# IEEE802.1Qay

## Project Status

# PBB-TE Current Status

# Mapping a customer instance to a PtMP TESI

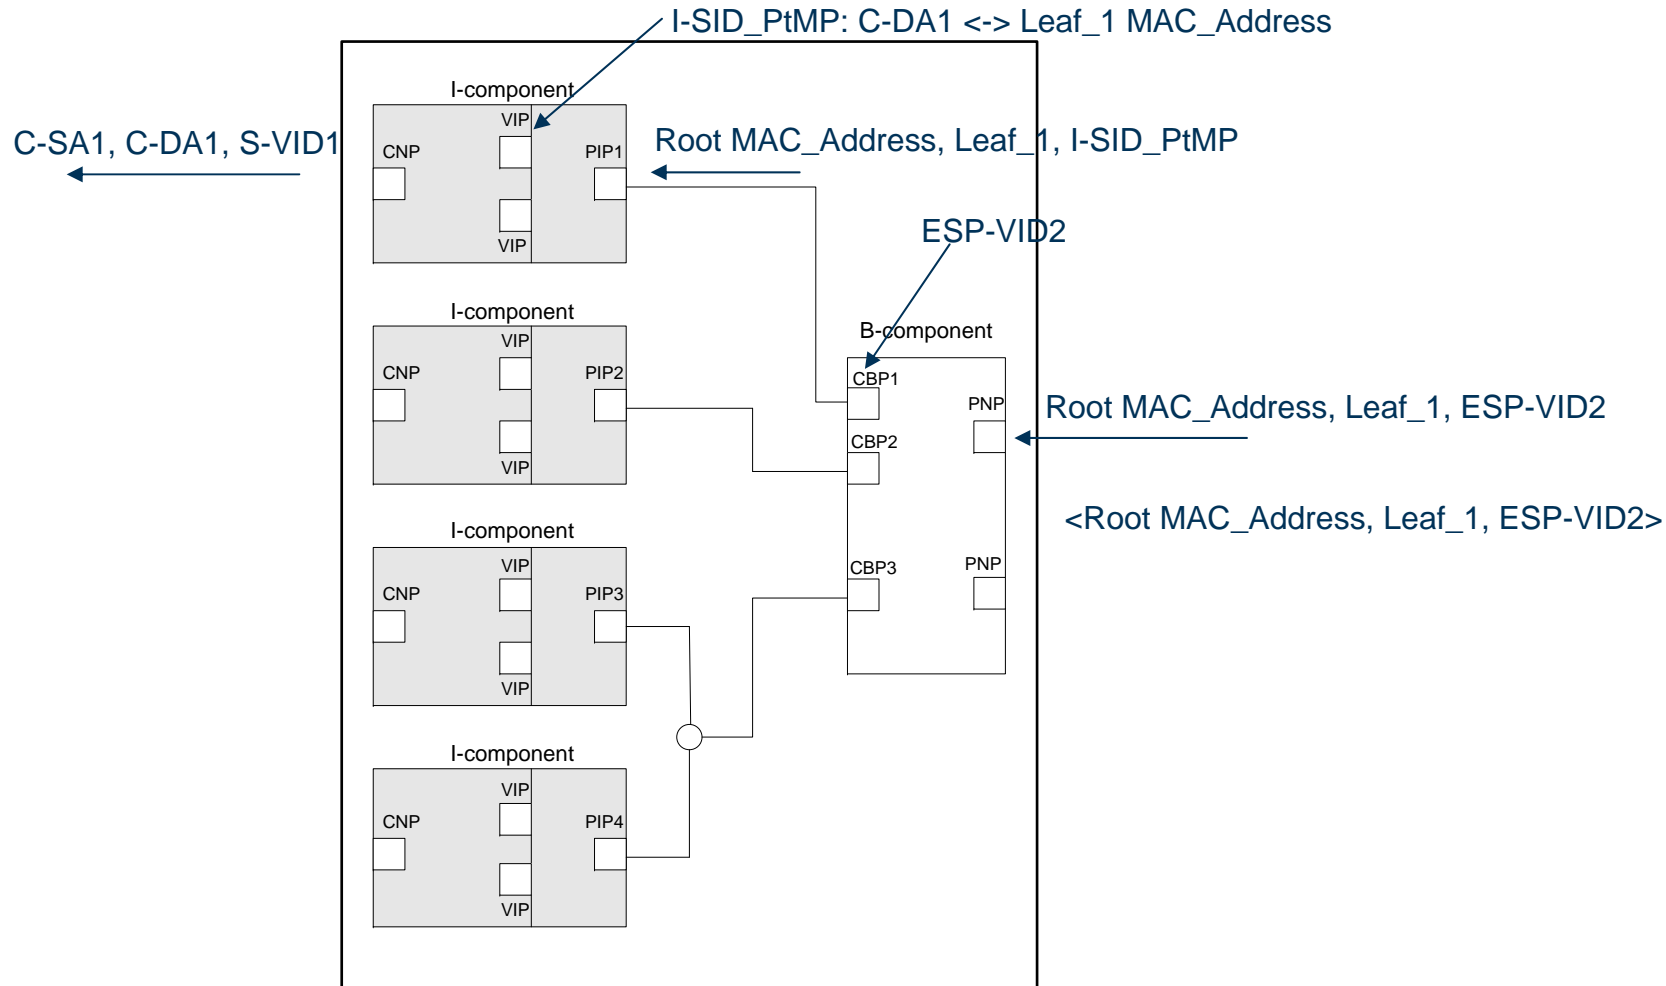
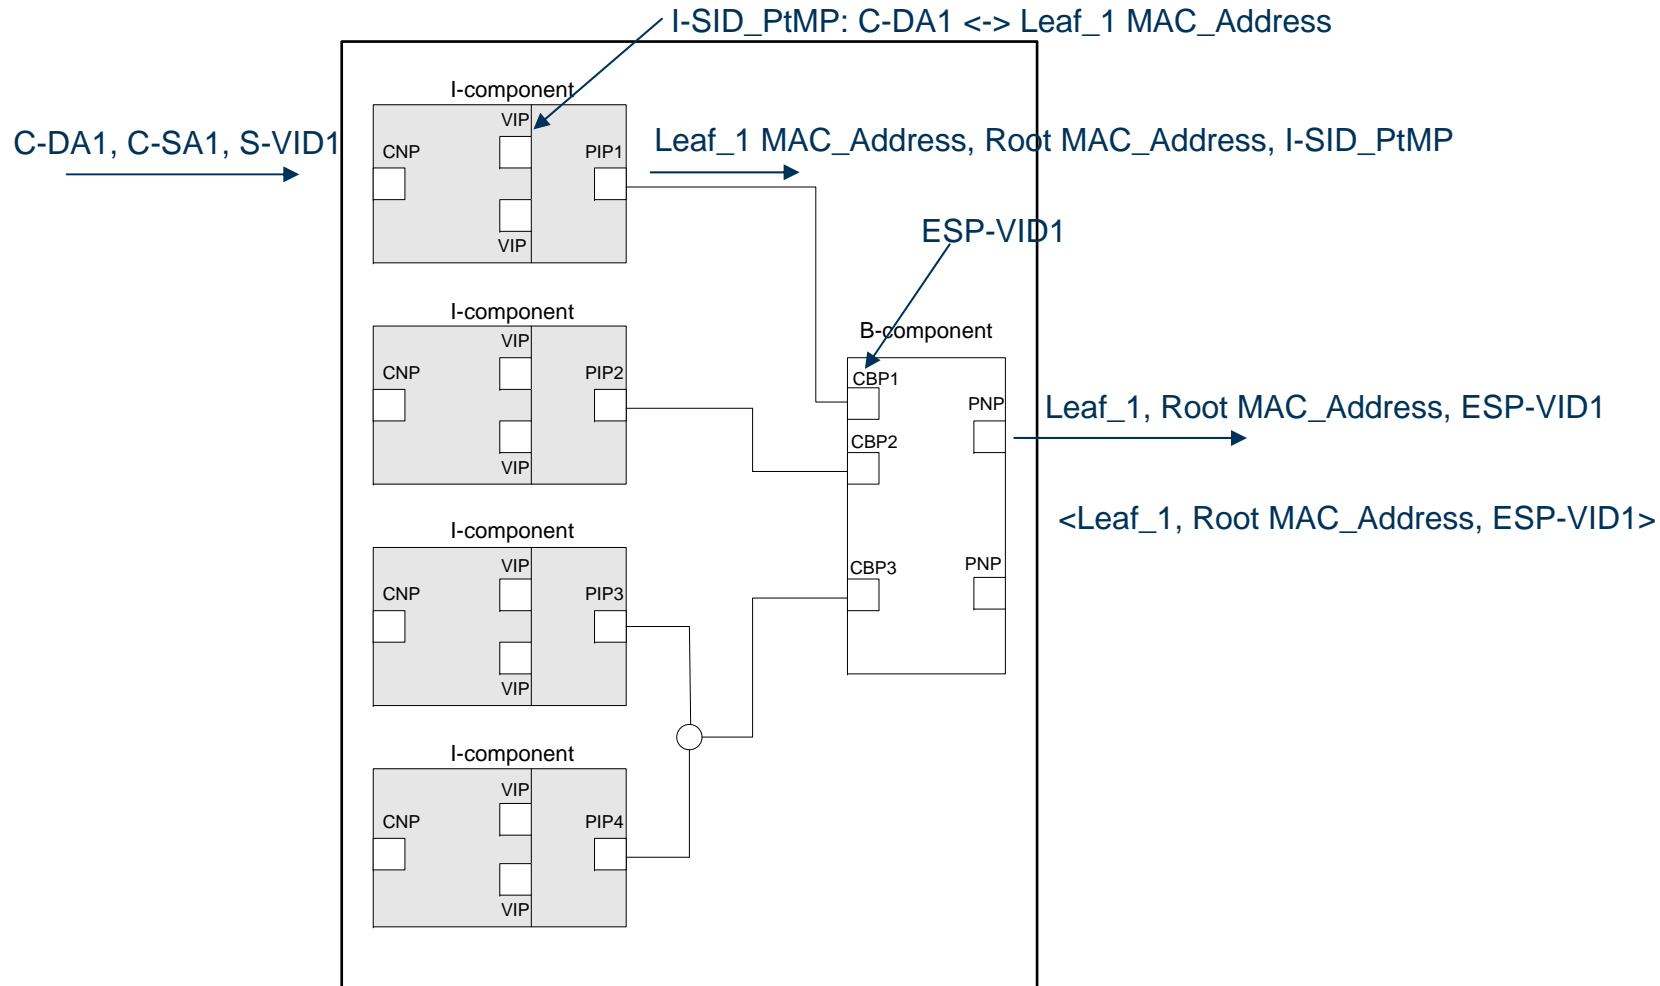
- Point-to-multipoint service encapsulation (#5, #115)
- Definitions (#56, #57, #88, #9, #35, #44)
- Protection Switching state machine (#15, #43, #124)

- A new parameter `enableConnectionIdentifier` on the VIP needs to be introduced.
- The default will be `True`.
- When configured to `false` the `connection_identifier` is always null on indications and ignored on requests.
